RE: Facility Inspection
Arrowhead Landfill
NPDES Permit # ALG160167
FID 35125.7
Perry County (105)
Inspected 4/17/2015

Alabama Department of Environmental Management
NPDES INSPECTION REPORT

**Re: Arrowhead Landfill
ADEM Facility Inspection Response Letter
NPDES Permit No. ALG160167
HHNT Project No. 3006-029-13**

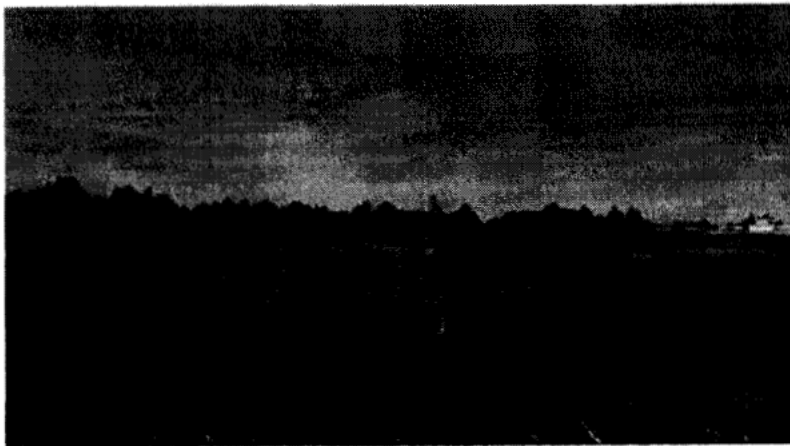
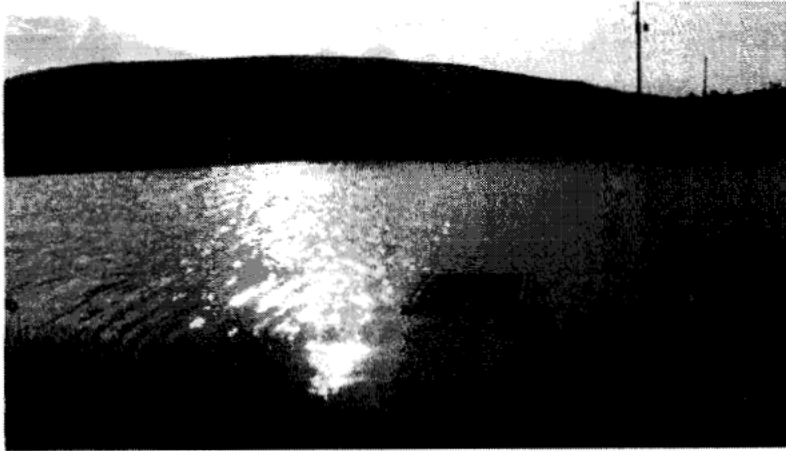
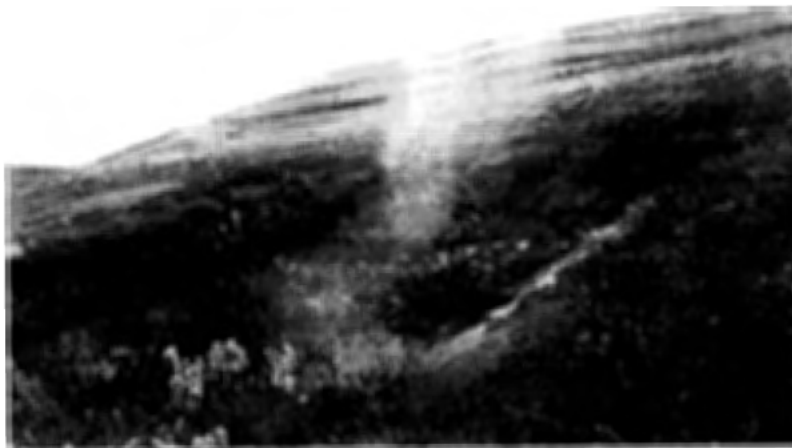
Comment No.	Comment	Photograph No.
1	No fuel or chemical storage. Leachate tank was within secondary containment.	
2	pH was analyzed out of holding time for samples collected on 6/29/2015.

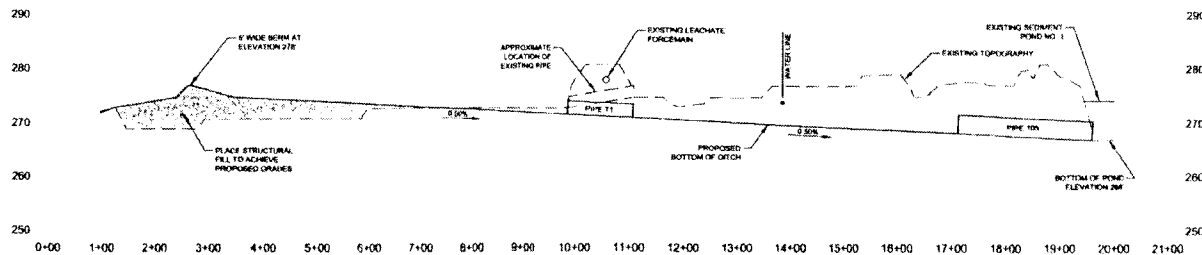
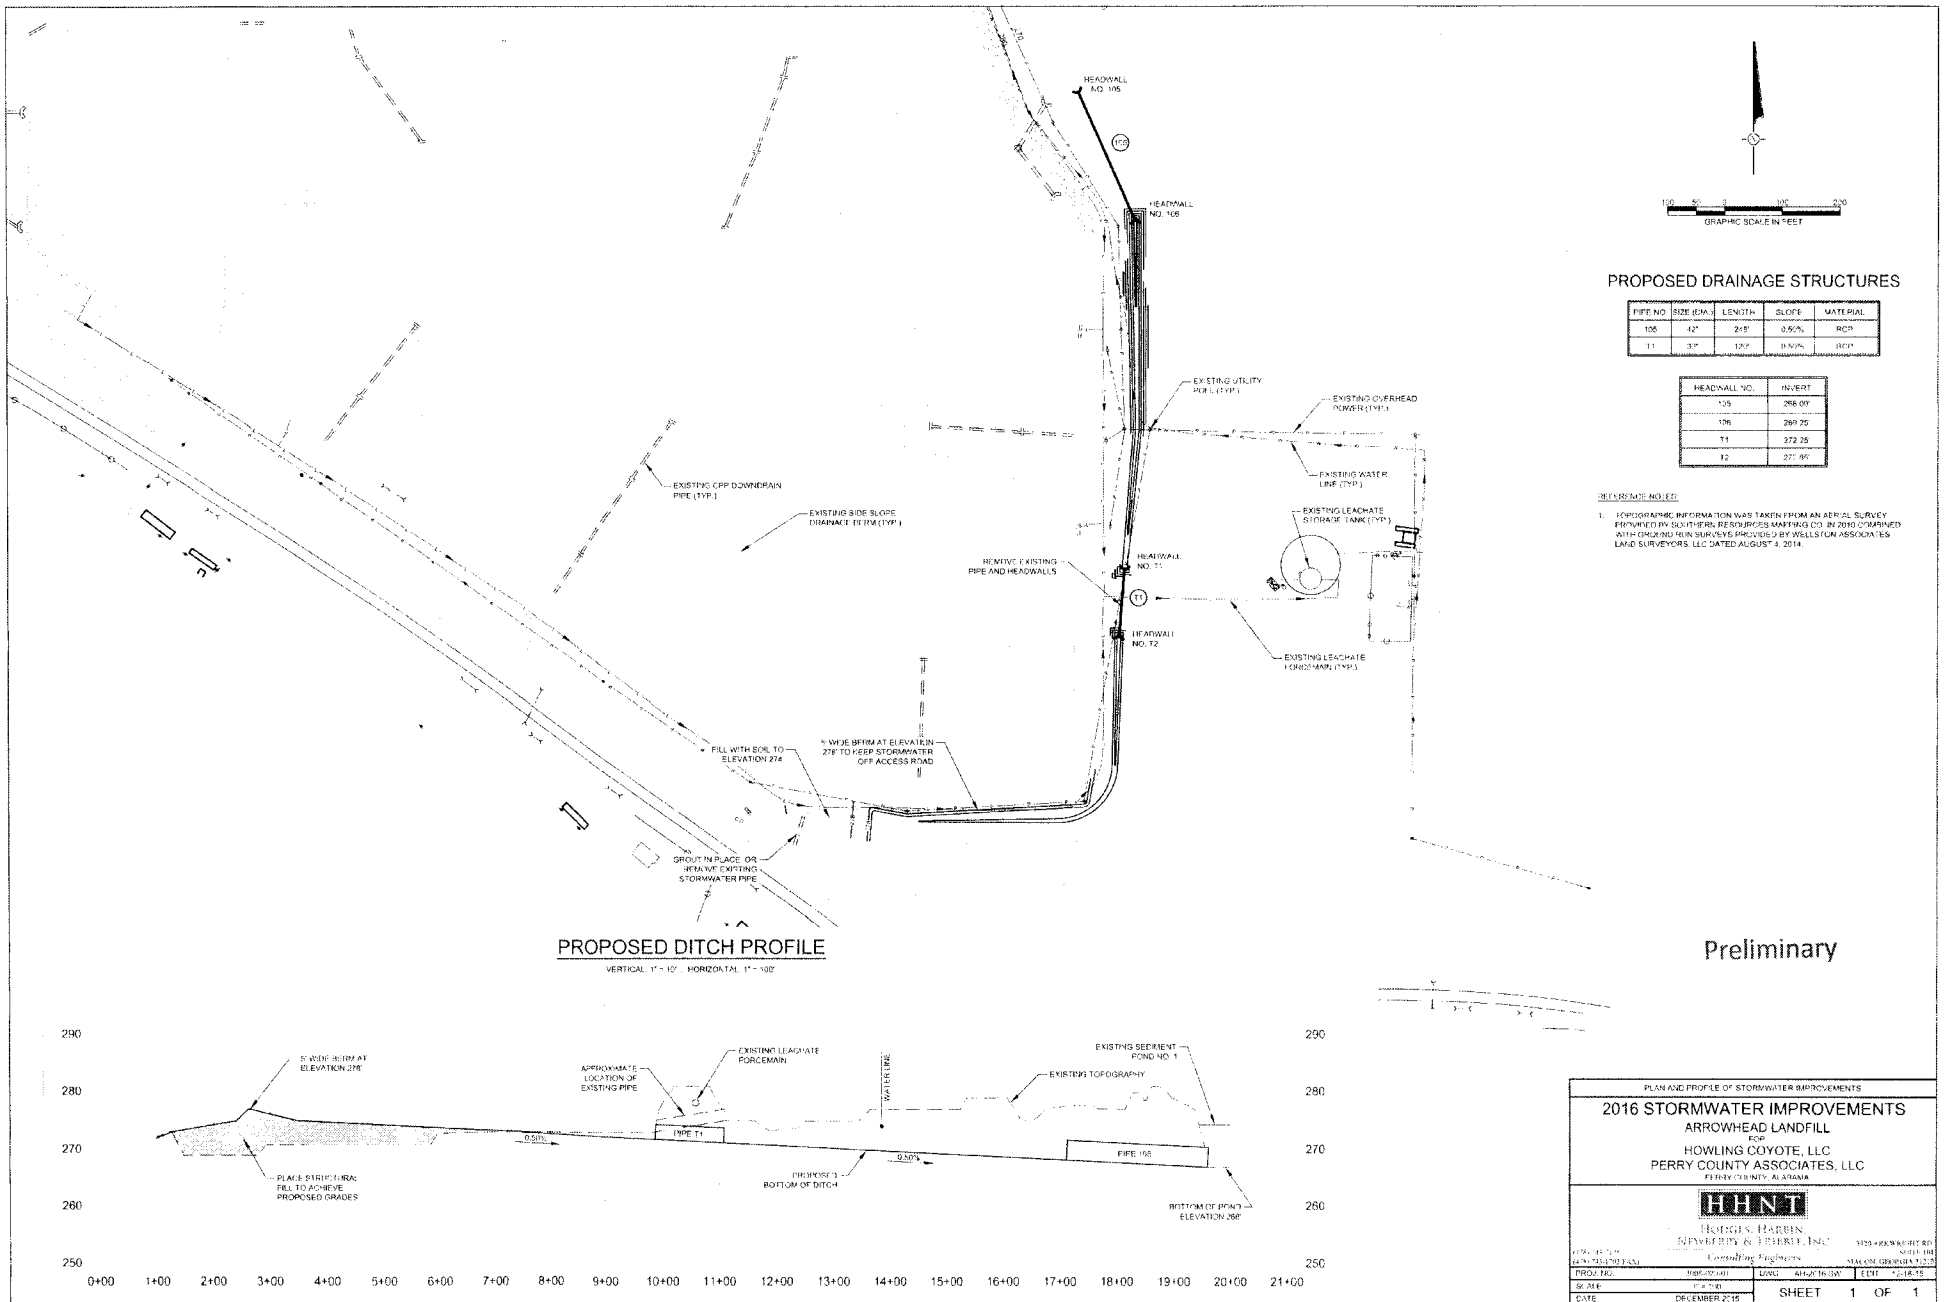
In response to recent citizen complaints and on behalf of Arrowhead Landfill, we have enclosed a plan sheet depicting planned storm water improvements on the southeastern portion of the property. The improvements include reversing the grade of the existing drainage ditch that runs along the corner of Cell 3 and discharges toward Cahaba Road. Instead of storm water runoff flowing south toward Cahaba Road and across the road to a tributary of Chilatchee Creek, the ditch will flow north to existing Sediment Pond No. 1. Discharges from Sediment Pond No. 1 will leave the site through the permitted Outfall No. 1 (DSN001-01, DSN003-02). Construction activities are planned for the first quarter of 2016 (weather permitting) and ADEM will be notified prior to construction initiation.
